## R99DE

Blue Bird Body Company has determined that certain Blue Bird All American forward engine buses equipped with Allison World transmissions do not conform to Federal Motor Vehicle Safety Standard No. 102 Section 3.1.3 pertaining to starter interlock requirements. On subject vehicles, the engine starter is operative with transmission selector in forward or reverse positions.

**RECALL R99DE**  
**ALL AMERICAN NEUTRAL SAFETY SWITCH NONCOMPLIANCE**  
**MODIFICATION INSTRUCTIONS**

FIGURE 1

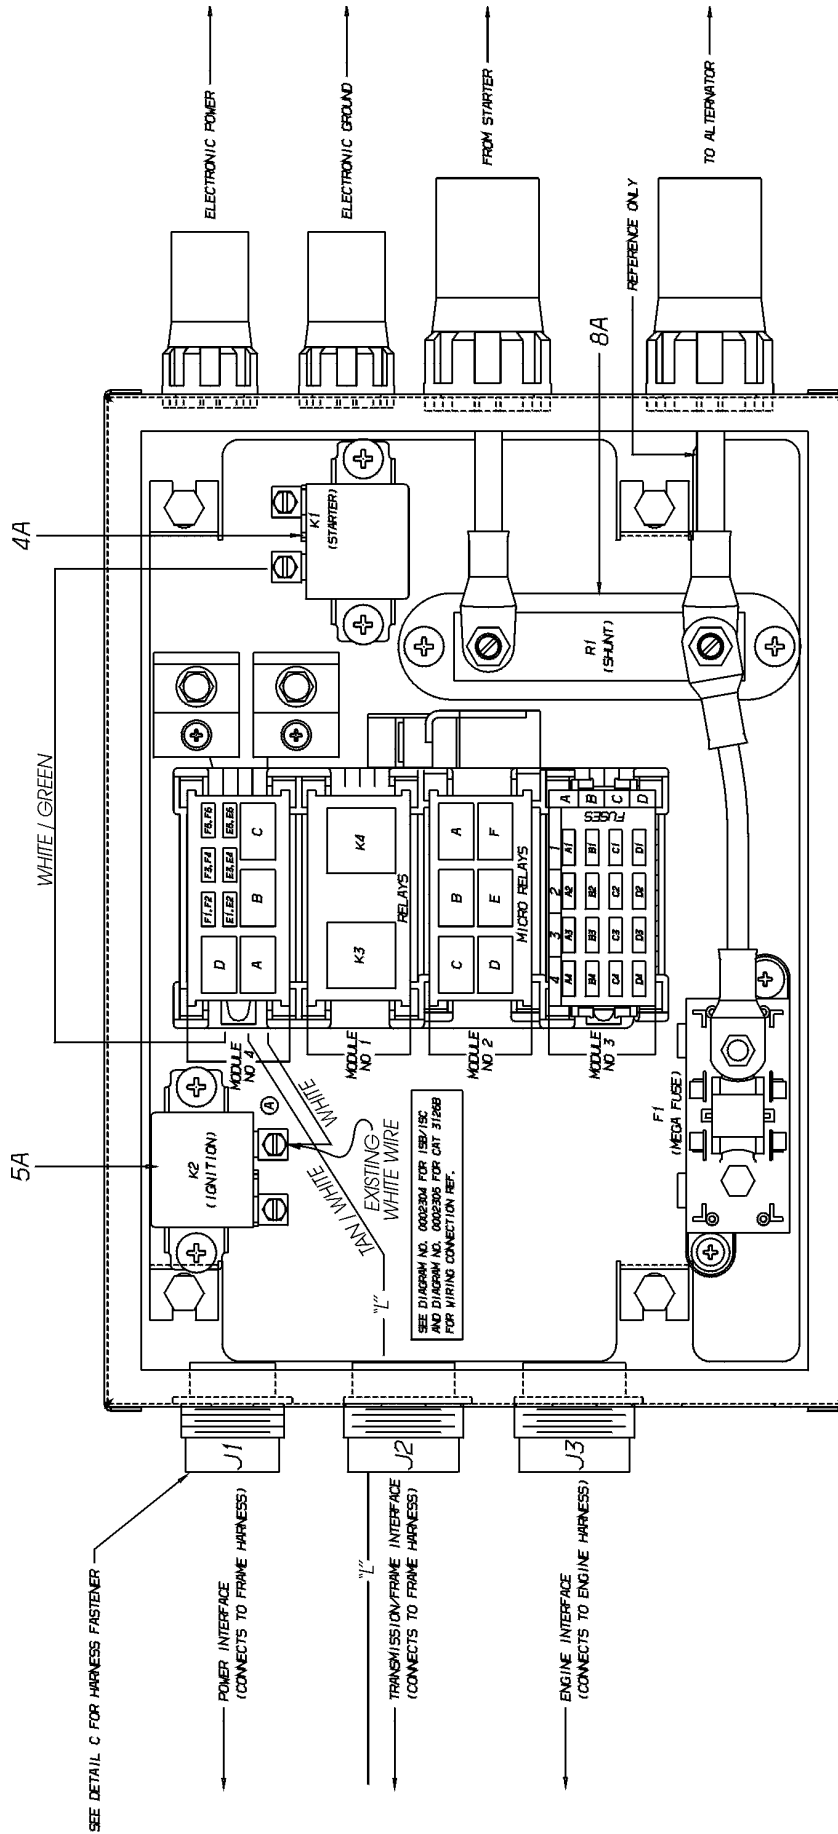
NOTE: Reference Figure 1 on page 3 for component locations.
4. Locate open position for module 4 (relay/fuse block) supplied.
5. Insert supplied relay/fuse block with wires extending out of left hand side of block, be sure all four mounting tabs are locked into place.

6. Remove two-way connector from starter relay located in upper right hand corner of PDU. (Location 4A)
7. Remove white /green wire, #18114, from connector. Remove end terminal and fold wire back against itself and tape.

8. Route green/white wire from new relay/fuse block to starter relay connector and install in location where wire #18114 was removed.
9. Install connector back onto the starter relay. (Location 4A)

10. Remove two-way connector from ignition relay located in upper left hand corner of PDU. (Location 5A)
11. Remove white wire, #1231, from connector and remove terminal.

12. Route white wire from new relay/fuse block to ignition relay.
13. Strip both white wires 3/16" and crimp on single 250 series terminal. (Supplied)
14. Install terminal with two white wires attached back into two-way connector in location where wire #1231 was removed.

15. Install connector back onto the ignition relay. (Location 5A)
16. Remove terminal sealing pins on harness connector plug and PDU receptacle in location "L". (See J2)

17. Insert tan/white wire from relay/fuse block into terminal “L” of female connector inside the PDU.
18. Insert tan/white wire #158 into terminal “L” of male connector on frame harness. (Location J2)
19. Follow harness forward approximately 20” to 12 connector plug. Remove secondary lock from connector and plug from terminal “C”. Insert 150 series pin into terminal location “C” of connector. (Matching connector will have circuit #18123, tan wire in matching location)
20. Install loom over wire and secure with nylon wire ties to existing harness.
21. Check wiring connections.
22. Replace PDU cover.
23. Reconnect battery ground cables.
24. Check ignition operation according to the chart below.
